**JOINT REGIONAL PLANNING PANEL
(Northern Region)**

JRPP No	2012NTH020
DA Number	DA12/0364
Local Government Area	Tweed Shire
Proposed Development	Construction of tourist accommodation development comprising of 355 tourist units, ancillary communal recreational facilities, on-site carparking for 375 vehicles and associated bulk earthworks, with access from the western extension of Kirkwood Road connecting to Fraser Drive.
Street Address	Firetail Street, Tweed Heads South
Applicant/Owner	Proportional Property Investment Ltd Atf PPI Wholesale Property Trust No 1
Number of Submissions	Two (2)
Recommendation	Refusal
Report by	Colleen Forbes, Coordinator Development Assessment
Report date	8 February 2013

Assessment Report and Recommendation

FILE NO: DA12/0364

Figure 2: Understorey clearing using heavy machinery or tracked machinery must be limited to the red polygon areas marked as A. No heavy or tracked machinery is permitted within the higher ecological value and conservation areas marked as B.

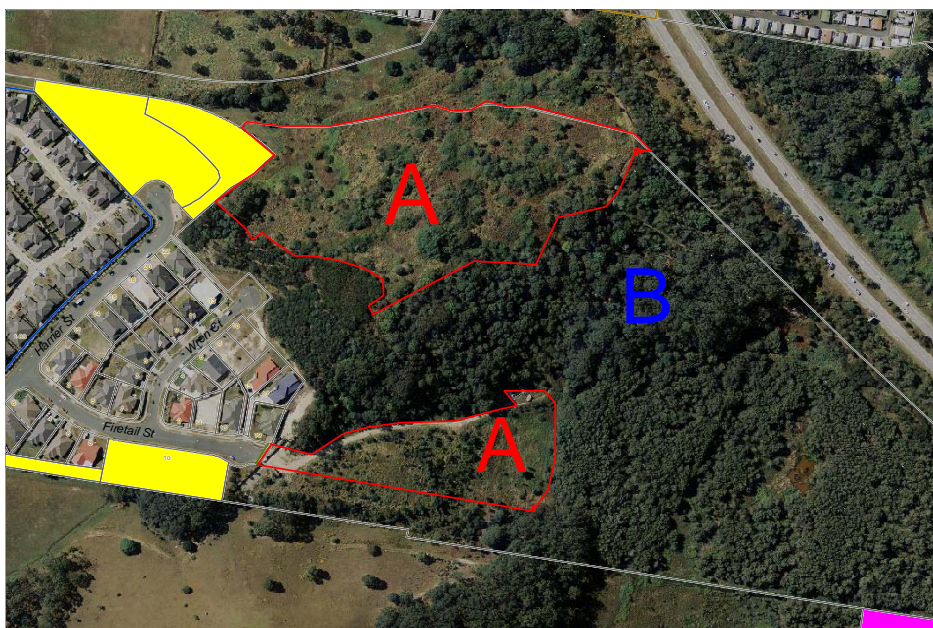
DA11/0388 proposed to remove the exotic undergrowth by mechanical means. The application was approved, with heavy or tracked machinery only permitted in certain areas of the site. No heavy or tracked machinery is permitted within the remainder of the, as shown below in Figure 2. It was also conditioned that weed control works within Area "B" may be undertaken only in a manner sensitive to the ecological values of the site using recognised bushland regeneration techniques.

Figure 3: Proposed revised covenant areas over the subject site.

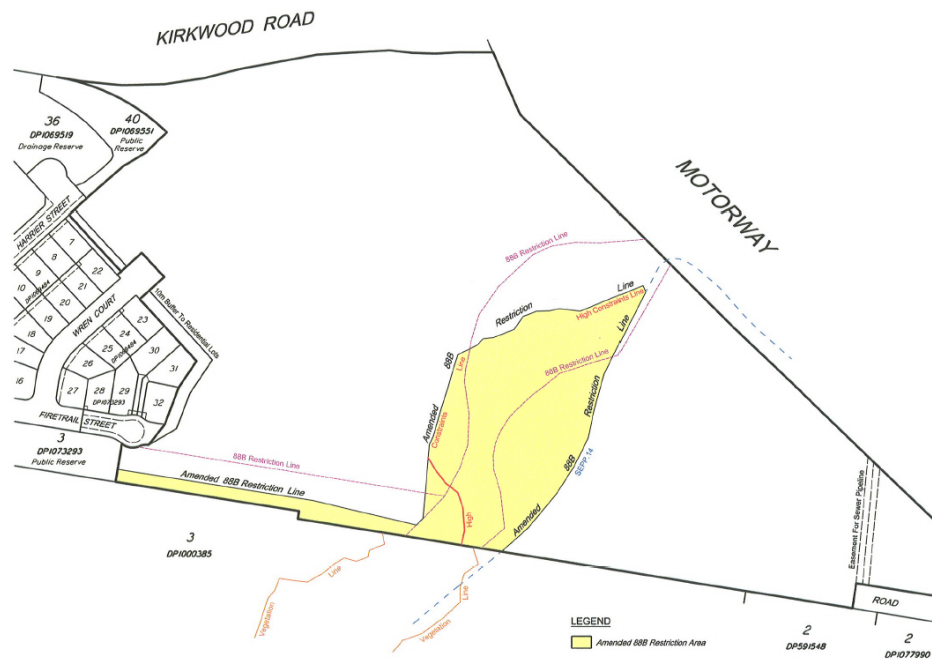
Consent conditions for K98/0011 included a requirement for a conservation zone through the central portion of the subject site, for the purposes of conservation and rehabilitation. The footprint of the proposed development appears to slightly overlap a portion of the zone. In this regard, the proponent has proposed to amend the conservation zone to more accurately align the conservation areas with the high conservation areas of the site. The revised conservation zone appears to be clear of the proposed development footprint, as shown in Figure 3 below.
